### 2638C AND 2639D TELEPHONE SETS

1.001 This addendum supplements Section 502-612-405, Issue 1.

1.002 This addendum is issued to:

Fig. 1—2638C and 2639D Telephone Set, Connections

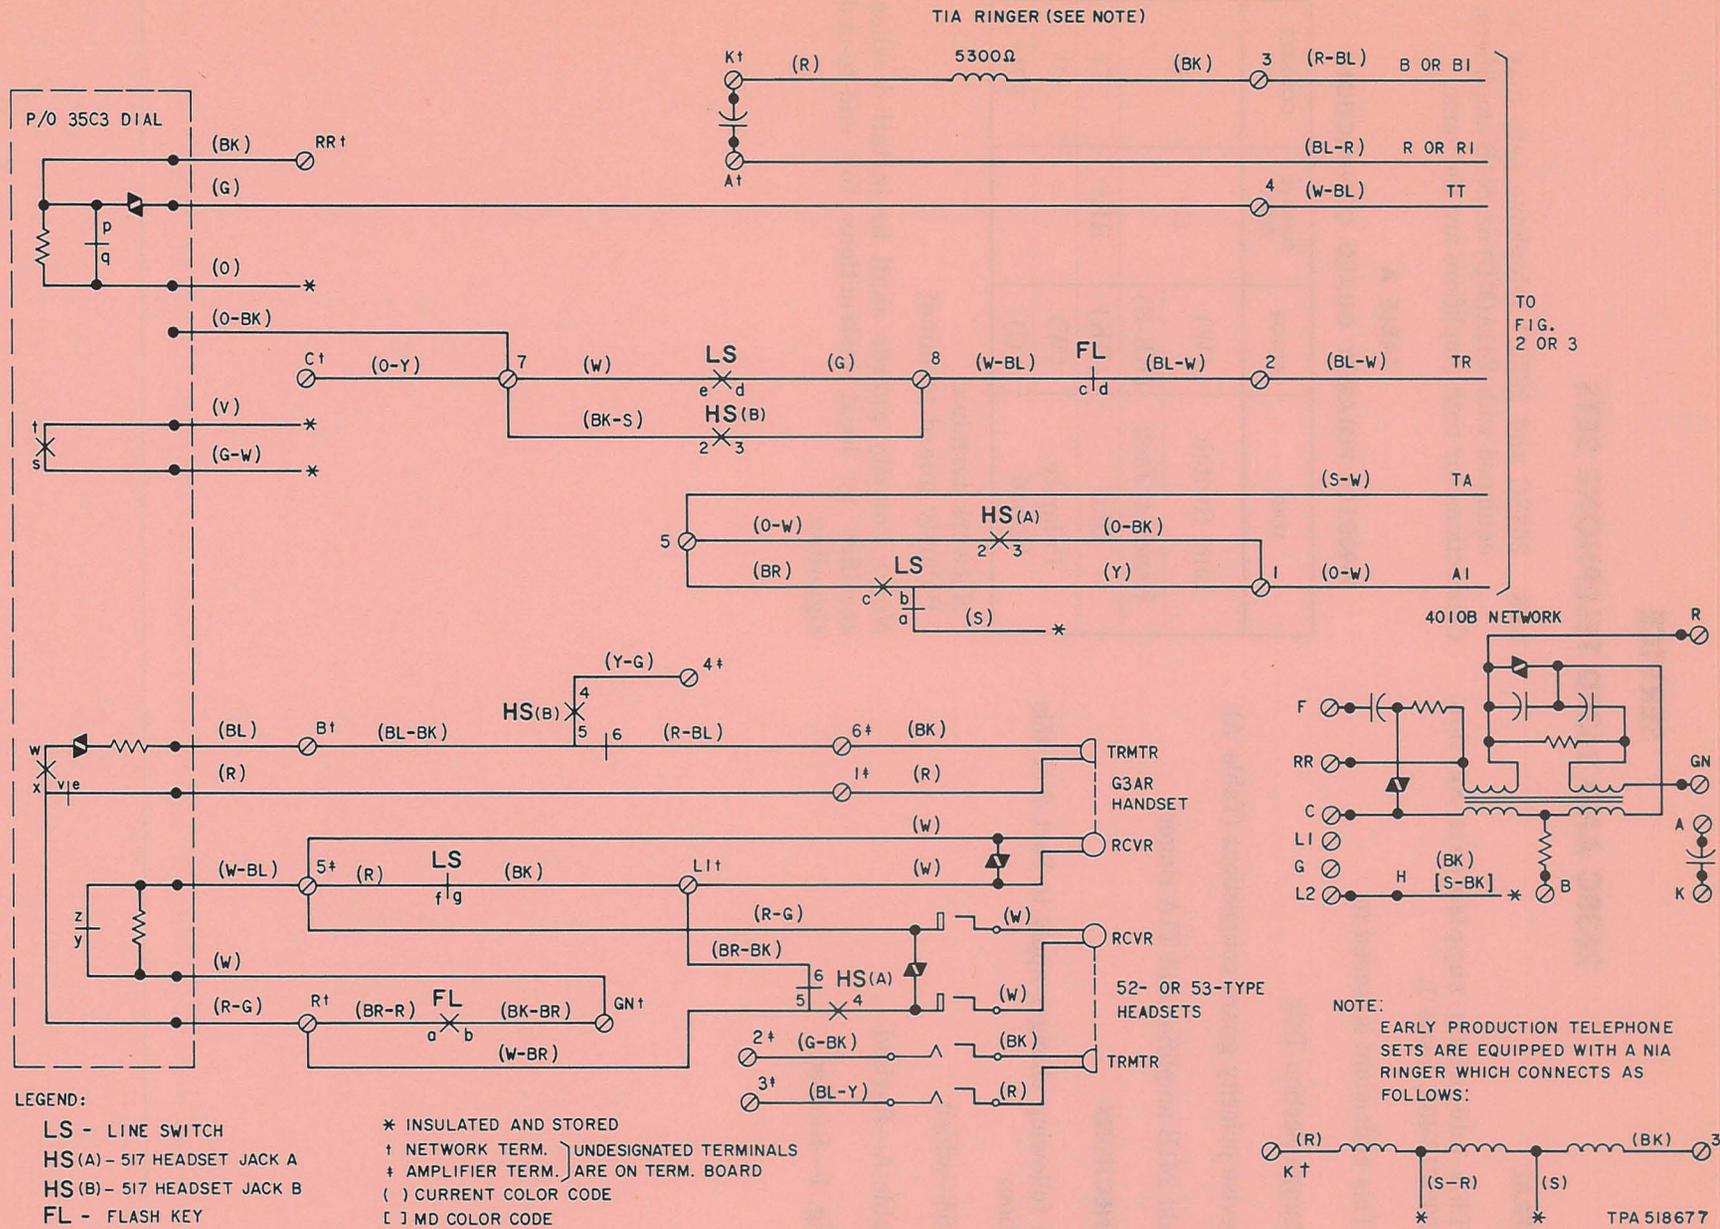
- (a) 2.08—added
- (b) Table A—Revised
- (c) Fig. 1—Revised

2.08 2638C and 2639D telephone sets may be equipped with 241A(MD) or 241B amplifiers. Connections for both amplifiers are the same.
